# ADDENDUM No. 1

RFP No. 22-49

## Ellsworth Road Sidewalk Gap Elimination

**PANEL 0401E**

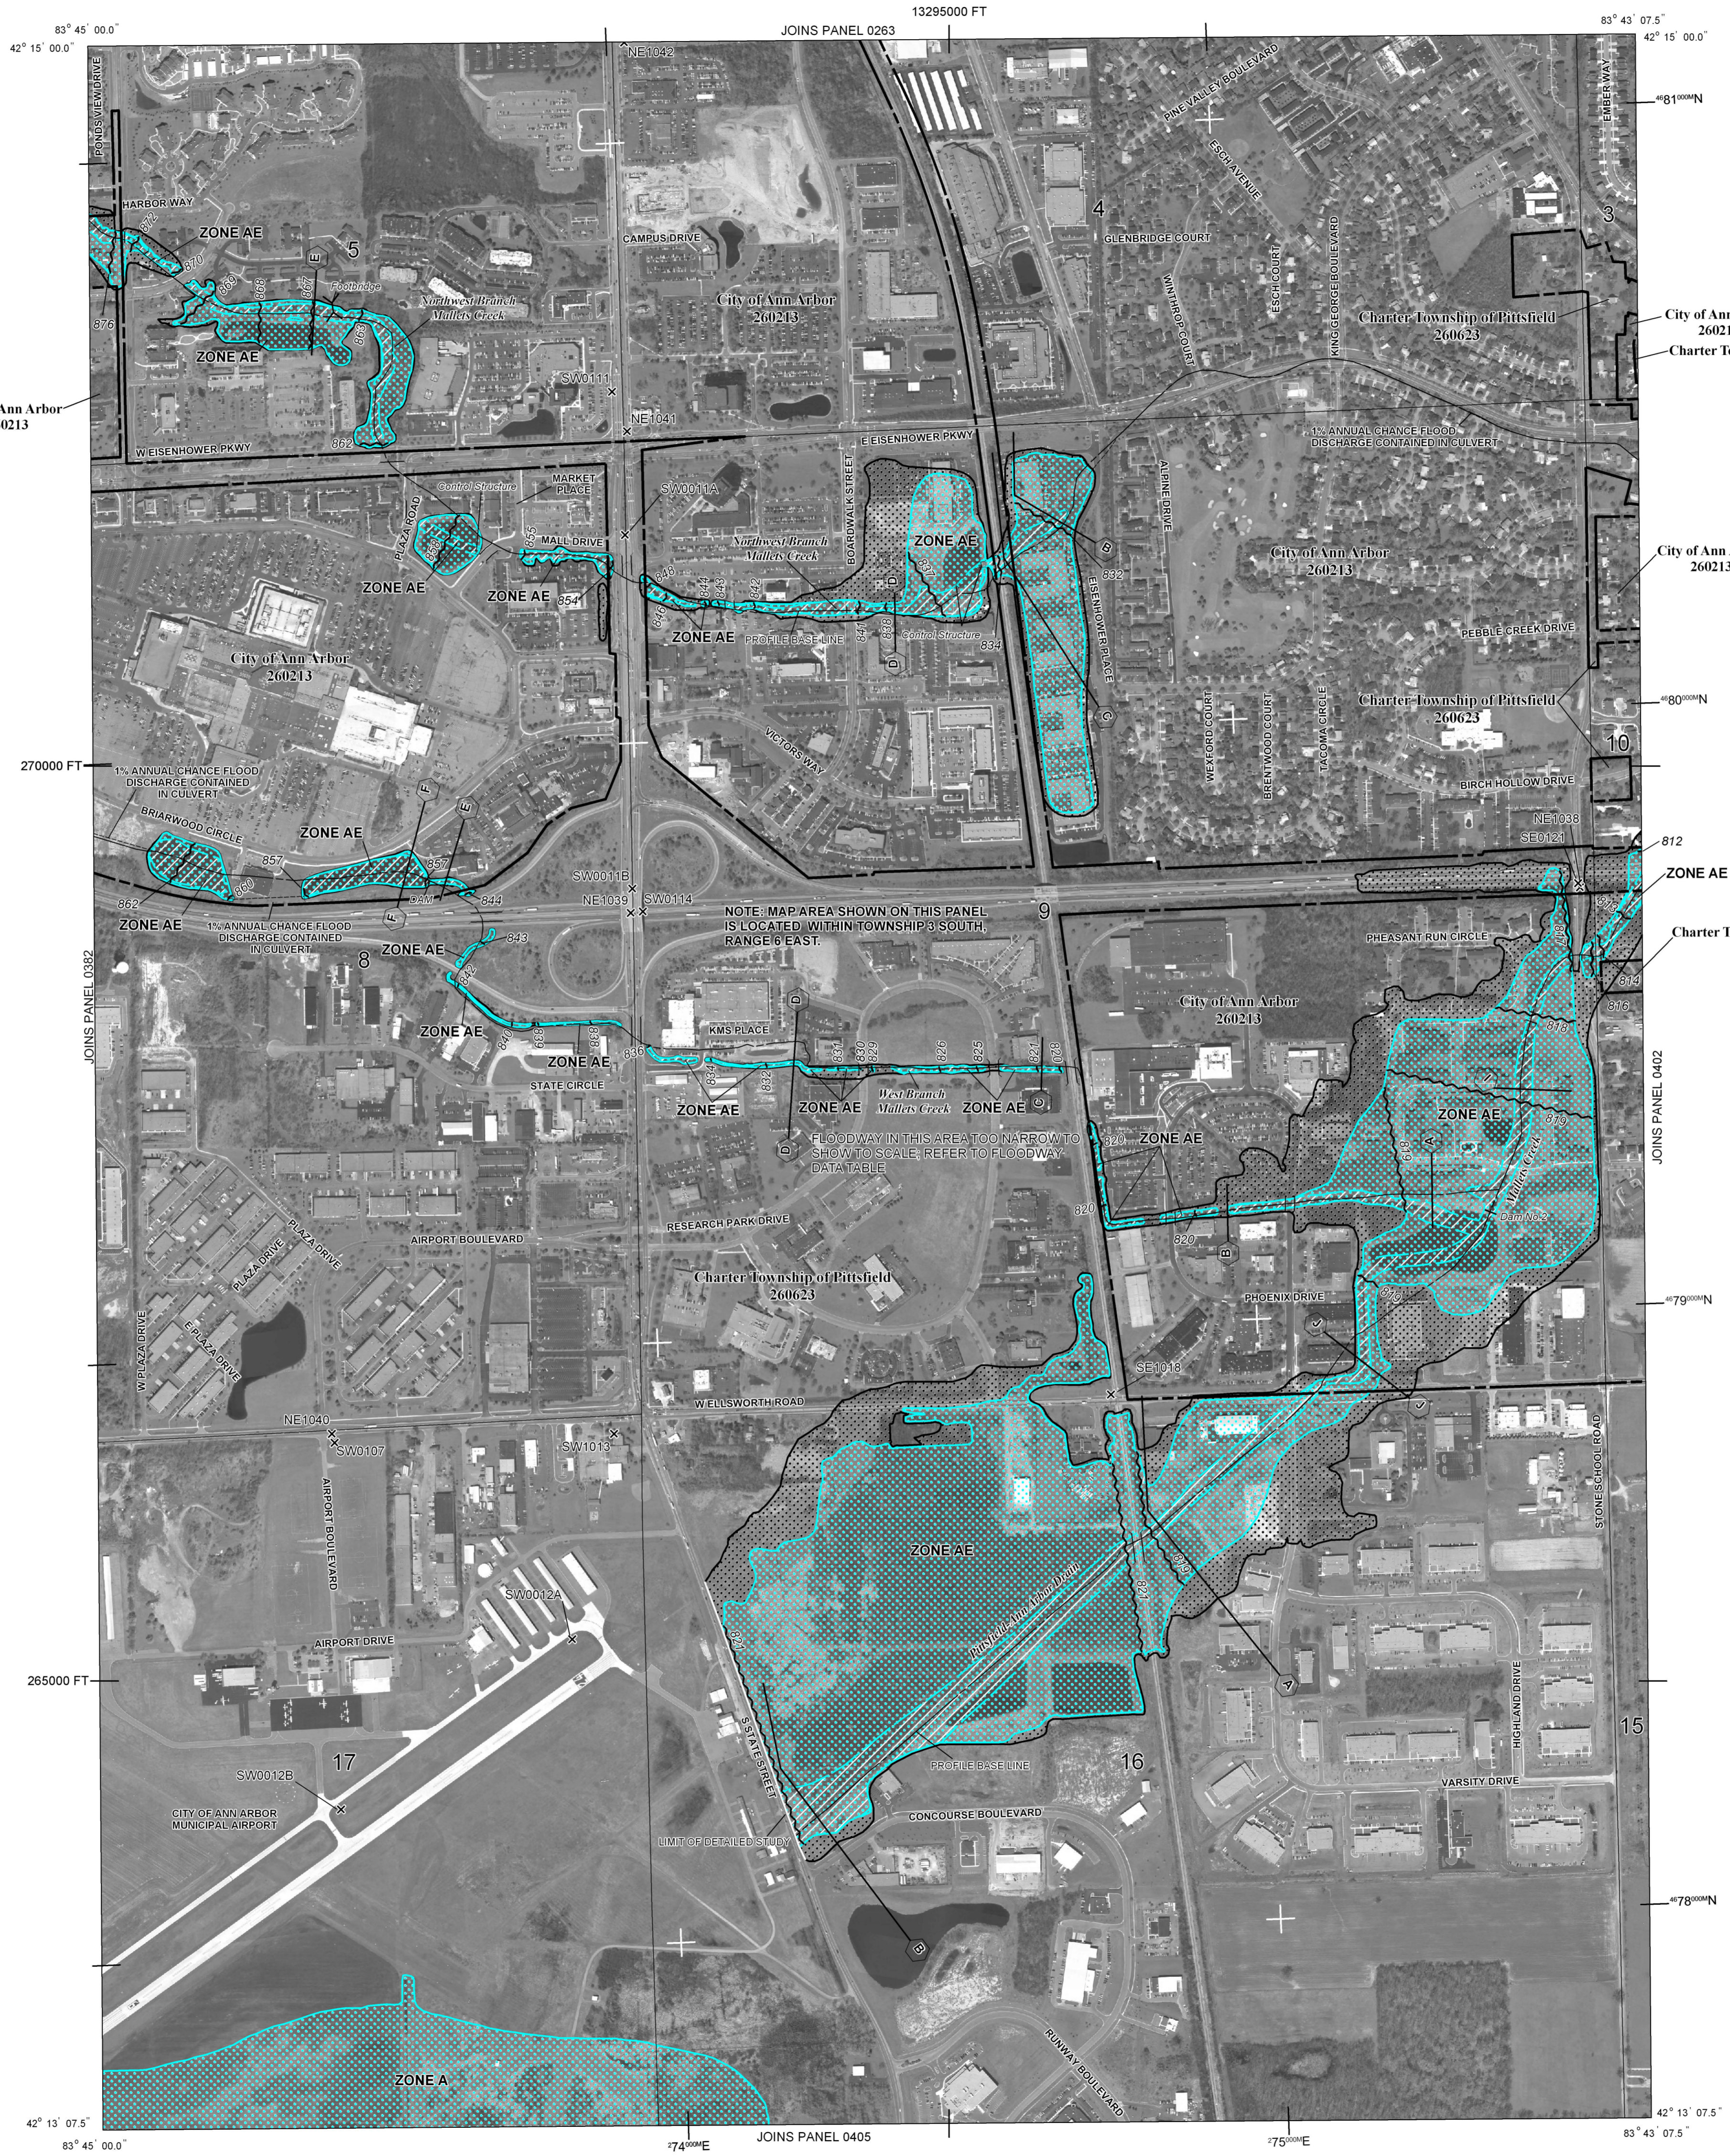
<b>Section/Page(s)</b>	<b>Change</b>
Detailed Specifications	Added Detailed Specifications for Pay Items 805, 806
<i>Comment: The intent with this change is to simply add Detailed Specifications For Items #805 and #806, pages DS805-Addendum1-1 to DS805-Addendum1-4 provided herein.</i>	
Appendix / FEMA Flood Insurance Rate Map	Added Overall Floodplain and Floodway Mapping
<i>Comment: The intent with this change is to simply add the Map provided herein.</i>

LEGEND & DETAILS

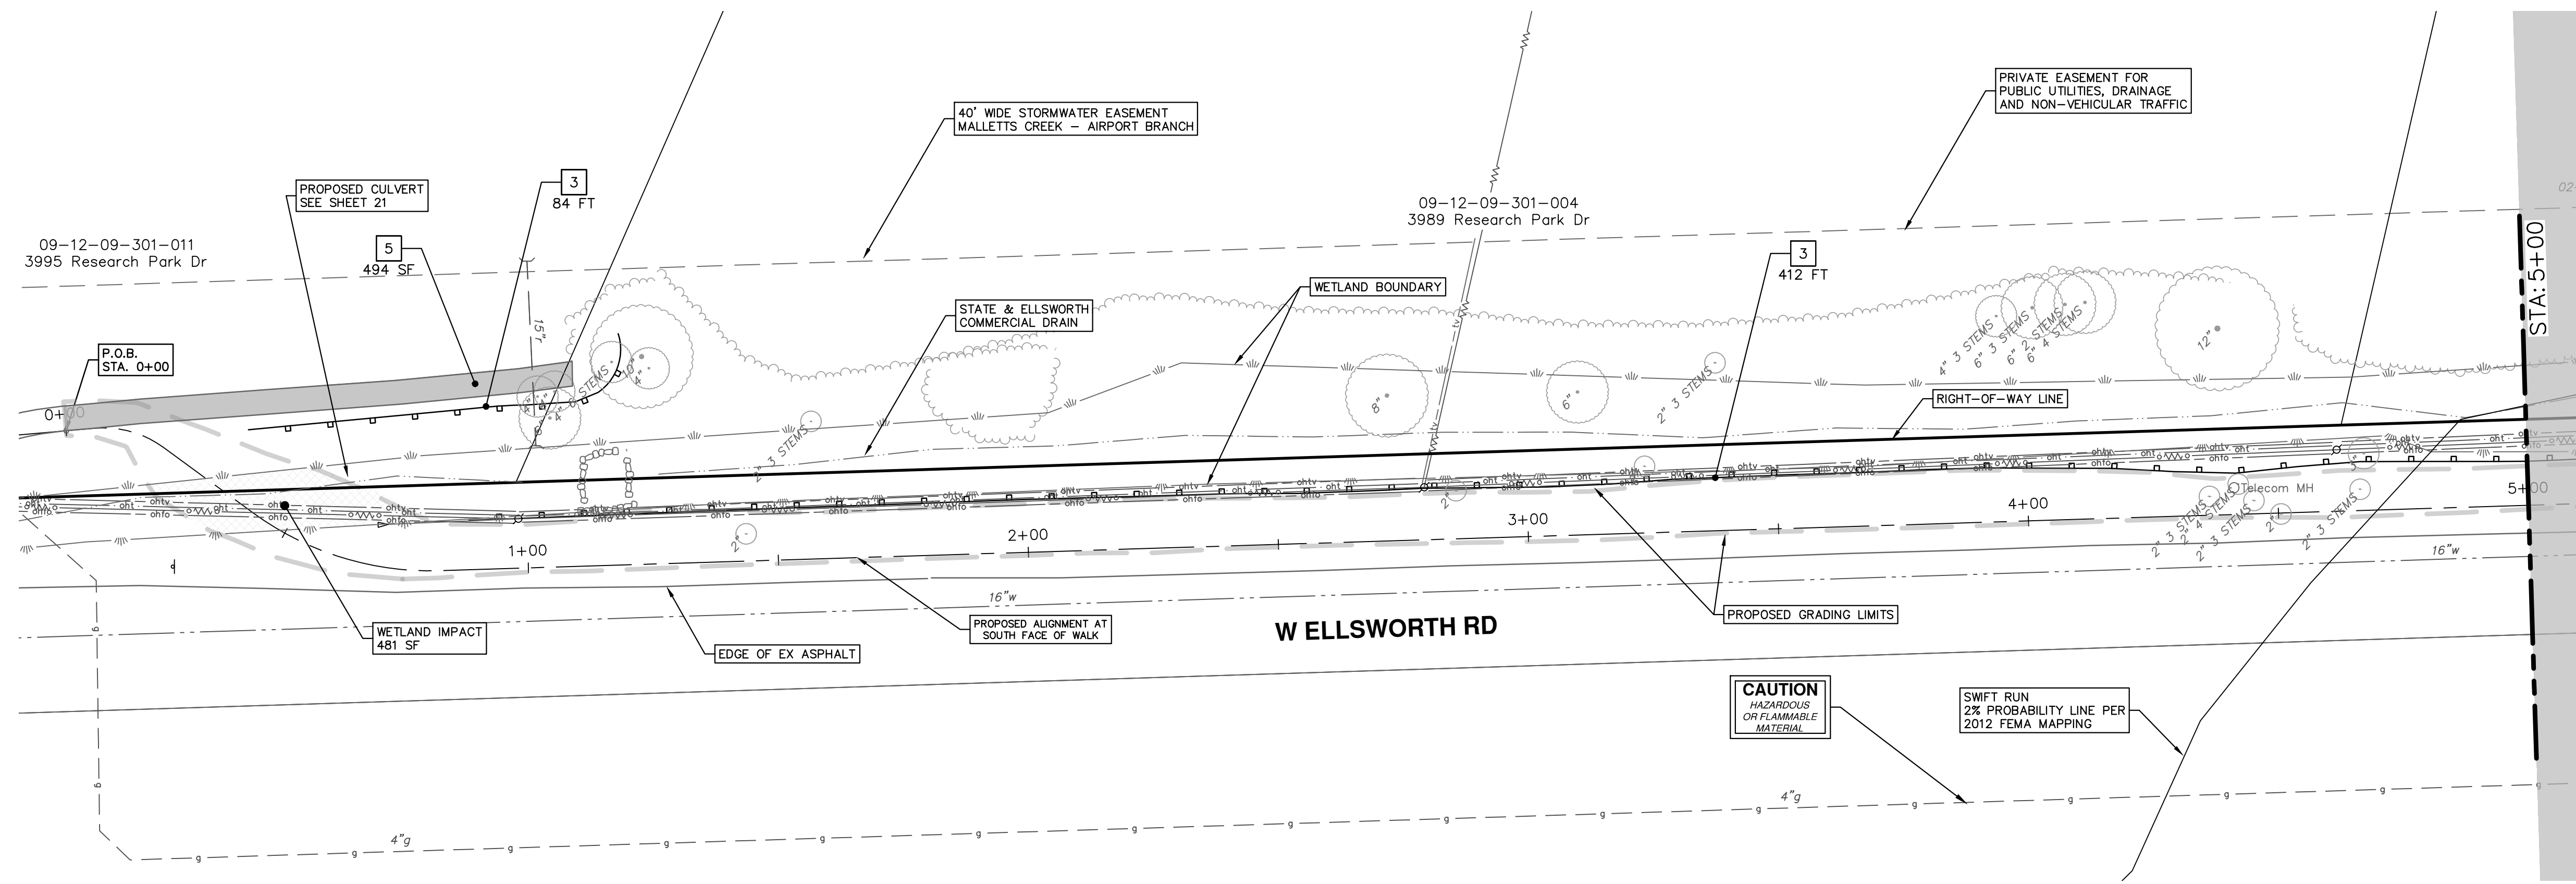
Drawing Plan / 3 of 24	Added Details.
Drawing Plan / 4 and 5 of 24	Removal Key Clarification to Remove HMA and Concrete (*Sawcut Full Depth at Removal Limits) Wetland Impact Quantities Separated on Sheets 4 and 5

SHEET No. 13 OF 24

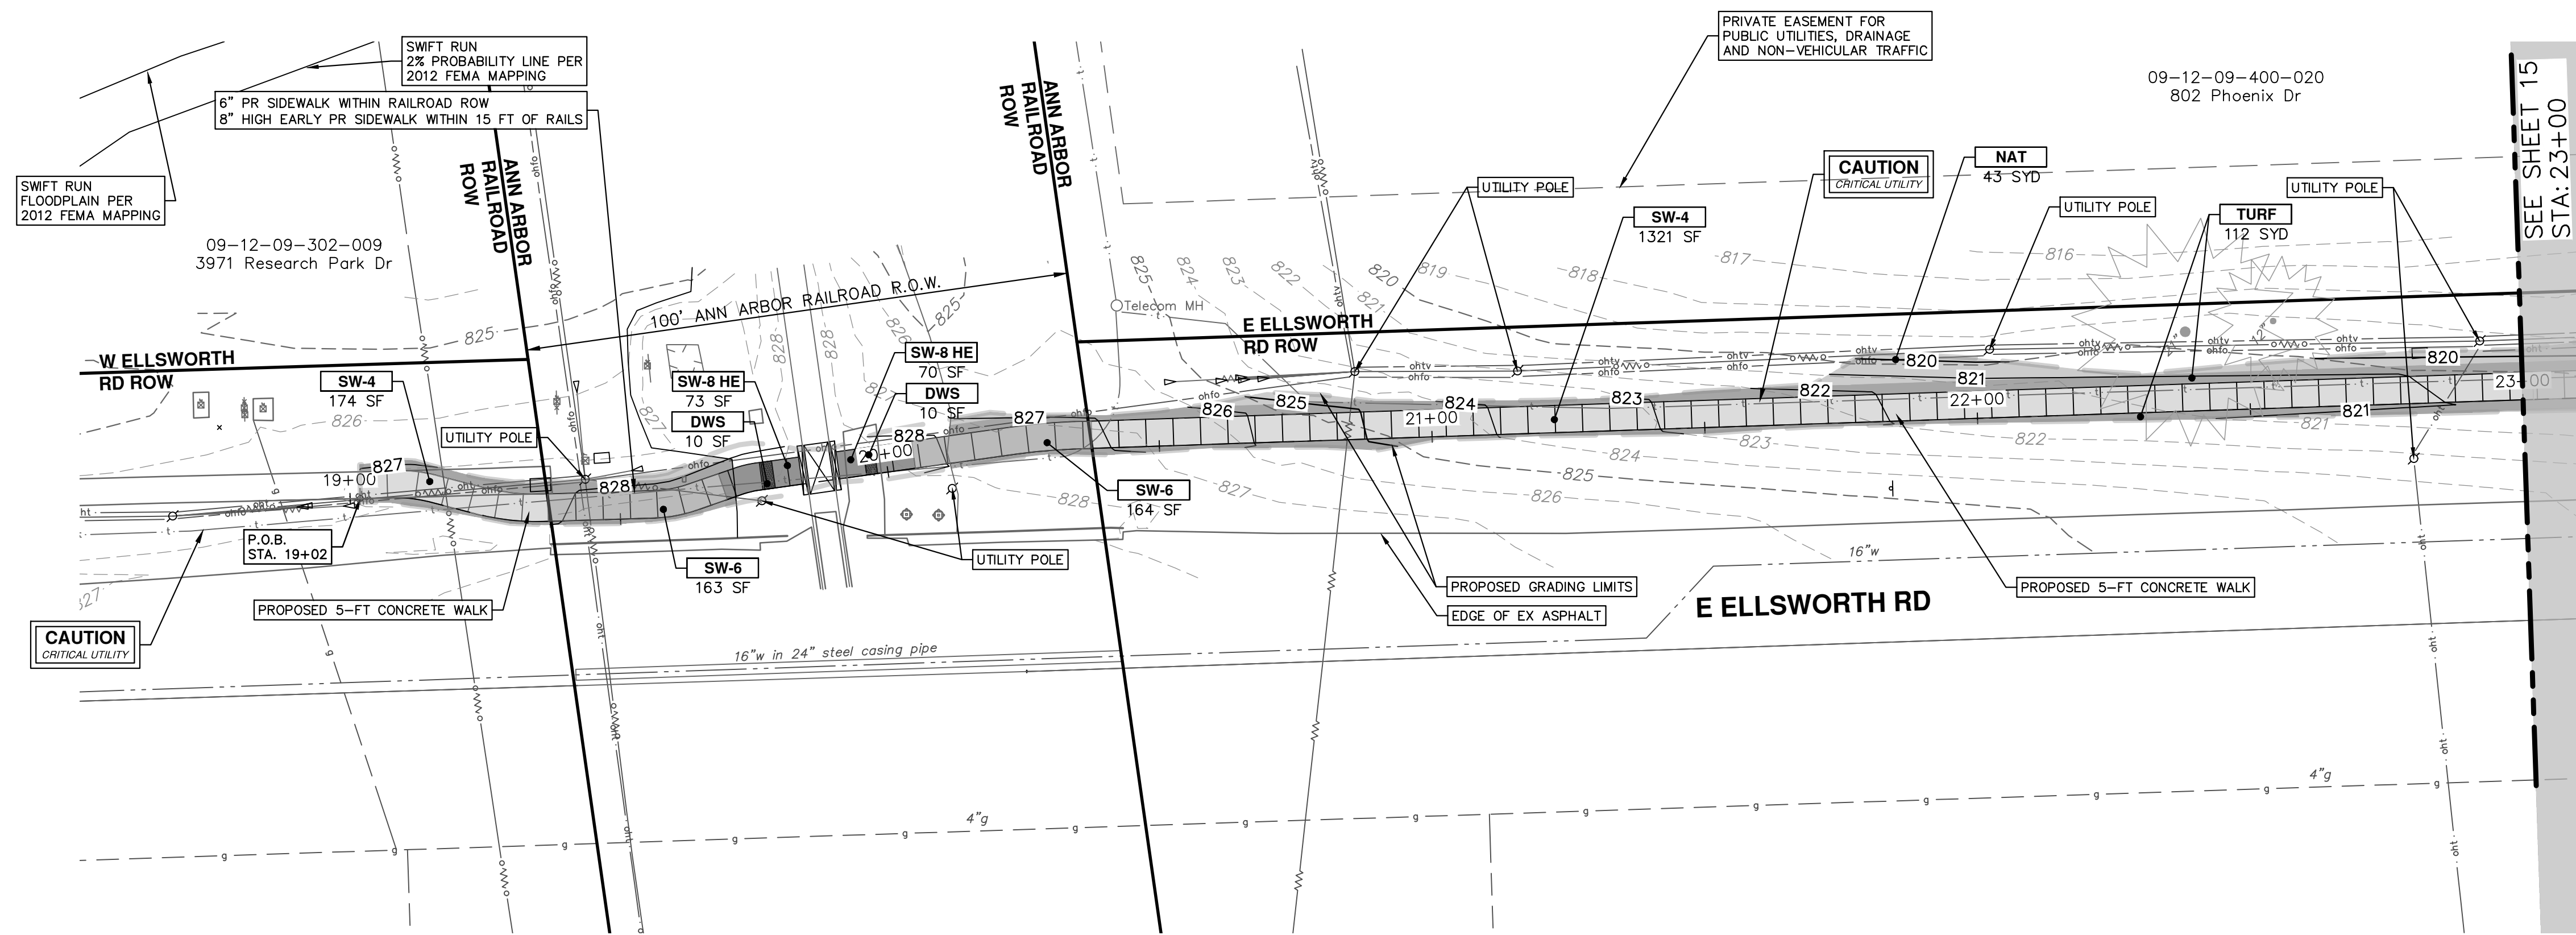
Drawing Plan / 13 of 24	Corrected Pay Item in Note Regarding Coordination with Ann Arbor Railroad
Drawing Plan / 21 of 24	15" Storm Sewer and End Section specified as Concrete

- 1: THE ANN ARBOR RAILROAD (AARR) WILL PROVIDE AND PLACE THE CROSSING MATERIAL OVER THE RAILROAD TRACKS. THE AARR SHALL ALSO PROVIDE AND PLACE A PEDESTAL MOUNTED PEDESTRIAN SIGNALS AND RR CROSSING SIGNS (W10-1) AT THE CROSSING FOR THE PROPOSED SIDEWALK. THE CONTRACTOR SHALL COORDINATE ALL SIDEWALK CONSTRUCTION WITH THE RAILROAD SO THAT THE WORK IS PERFORMED IN A LOGICAL MANNER WITHOUT DISRUPTION TO THE AARR SERVICE, SIGNAL WIRES, OR ANY OTHER RELATED FEATURE AT OR NEAR THE SITE AS DIRECTED BY THE ENGINEER. THE CONTRACTOR IS TO ACCOUNT FOR THE AARR'S WORK WITH RESPECT TO THE INSTALLATION OF THE CROSSING MATERIAL, THE PEDESTAL MOUNTED PEDESTRIAN SIGNALS, AND SIGNAGE SO THAT THEIR CONSTRUCTION OPERATIONS ARE NOT DELAYED. PAYMENT FOR COORDINATION WITH THE AARR INCLUDED IN "SIDEWALK STATION GRADING, RAILROAD ROW".
